CDM: Recommendation Form for Small Scale Methodologies (version 01)
(To be used for presenting questions/proposals/amendments to the simplified methodologies for small-scale CDM project activity categories)

<i>Date of SSC WG meeting:</i>	15–18 March 2011, SSC WG 30
<i>Title/Subject (give a small title or specify the subject of your submission, maximum 200 characters):</i>	Clarification on the applicability of AMS-III.H to wastewater treatment in new anaerobic facility and existing aerobic facility
<i>Indicative methodology to which your submission relates (refer the items of Appendix B of the Simplified Modalities and Procedures), if applicable.</i>	AMS-III.H “Methane recovery in wastewater treatment”
<i>Name of the authors of the query:</i>	Soichiro Miyashita Institution: EJ Business Partners miyashita-so@ej-hds.co.jp

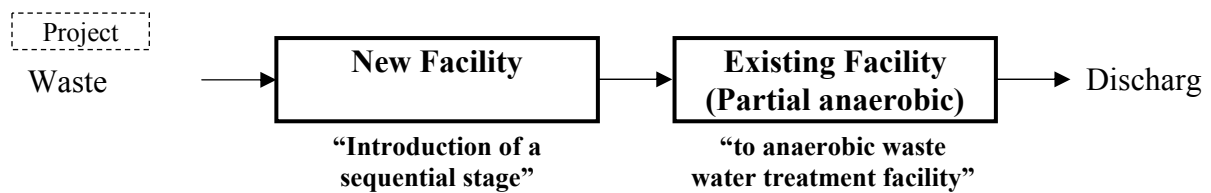
2) The applicability condition 1(f)

That means if the treatment condition of the Existing Facility is considered as a partial anaerobic because the current treatment condition is under overloading and not complete aerobic, the New Facility will be interpreted to be introduced at a "sequential stage" of the Existing Facility which is partially anaerobic without gas recovery equipment.

The SSC WG agreed to clarify that Technology/Measure of 1(f) in the AMS-III.H, version 16 is applicable to the proposed project activity, only when it can be proven that the anaerobic condition/pockets exist due to the overloading of the existing facility. In doing so, a measurement campaign can be conducted to measure the dissolved oxygen level (DO) by following the principle of conducting measurement campaign in paragraph 27(b), in AMS-III.H version 16, i.e. the measurements should be undertaken during a period (minimum 10 days) that is representative for the typical operation conditions of the systems and ambient conditions of the site (temperature, etc). If the measured DO level is less than 1 mg/L as specified in paragraph 22 of AMS-III.I version 8 "Avoidance of methane production in wastewater treatment through replacement of anaerobic systems by aerobic systems", the MCF value of 0.3 for poorly managed, overloaded aerobic system in AMS-III.H, version 16, can be chosen.
